1984 Corvette: Service Bulletin: Generator Noise (Moan) at Idle with Air Conditioning On

Model and Year: 1984 Corvette

Bulletin Number: 84-151, Section 6D (VIy)

Date: June 1984

FIGURE 1

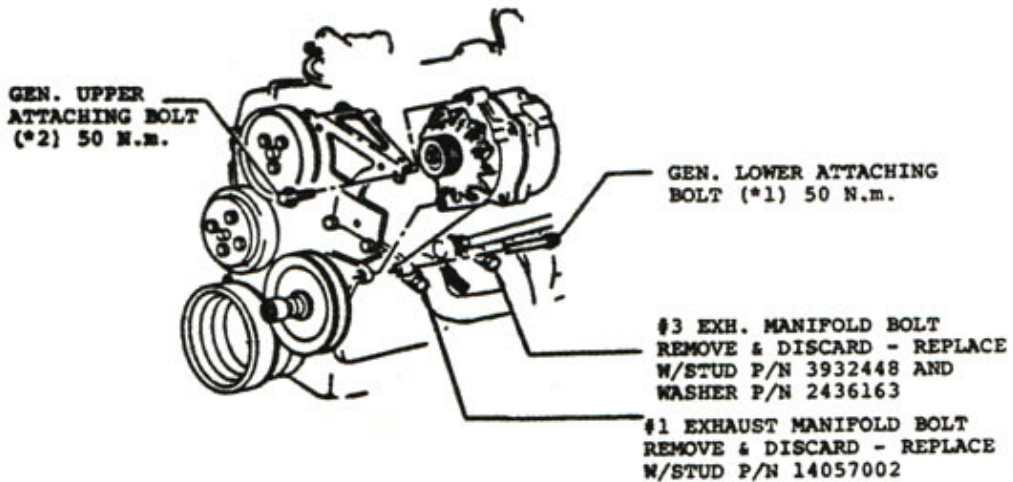
Some 1984 Corvettes may exhibit the subject noise, which is commonly defined as a "moan". This noise is induced into the generator by belt excitation when the air conditioning compressor is "on".

The following service procedure has been developed to reduce this noise by using three (3) new tubular braces and fasteners to replace the generator vibration period, which is the primary noise source.

1. Remove the generator rear support brace. Discard the support brace, attaching nut and attaching bolt.
 2. Remove and discard #1 and #3 L.H. exhaust manifold to cylinder head attaching bolts (see Figure 1).

- NOTICE: Washer is to be installed on stud between stud hex and exhaust manifold.
5. Remove the serpentine belt from the generator pulley.
 6. Loosen generator attaching bolts (2). (See Figure 1).

3. Install stud, P/N 14057002, in place of discarded #1 bolt and torque to 35 N.m.
 4. Install stud, P/N 3932448, and washer, P/N 2436163, in place of discarded #3 bolt and torque to 35 N.m.

9. Mandatory torque sequence (Figures 1 and 2):

- Generator lower attaching bolt 50 N.m.
- Generator upper attaching bolt 50 N.m.
- Long tubular support brace to generator, attaching bolt 35 N.m.
- Two (2) short tubular support braces to generator, attaching bolt 50 N.m.
- Three (2) tubular support braces to three (3) exhaust manifold studs, 25 N.m. three (3) attaching nuts.

FIGURE 2

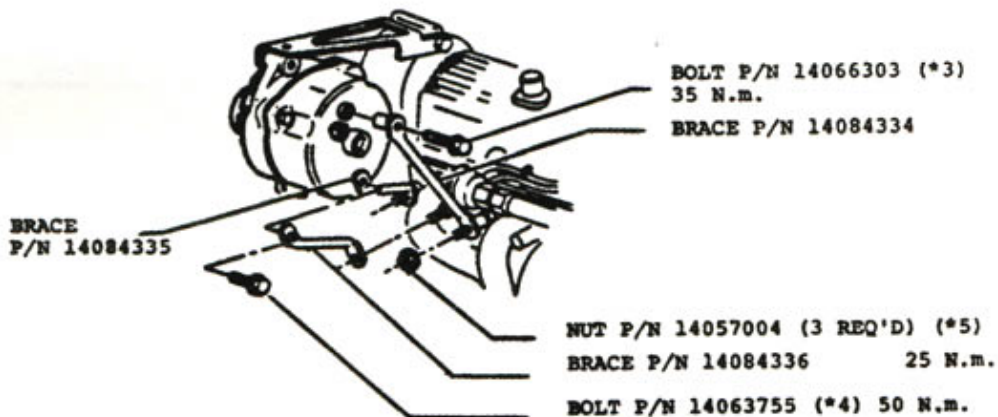
7. Install three (3) tubular braces on the exhaust manifold studs as shown on Figure 2 and loosely retain with attaching nuts in three (3) places.
 8. Install bolt, P/N 14066303, in longer single brace and bolt, P/N 14063755, in two (2) short braces. Loosely install bolts into generator housing (see Figure 2).

The B+ wire on the generator should not contact the support brace(s). If necessary, disconnect the battery and loosen the B+ cable eyelet, on the generator, and rotate the B+ wire to clear the support brace(s). Re-torque the eyelet attaching nut and install the battery cable.
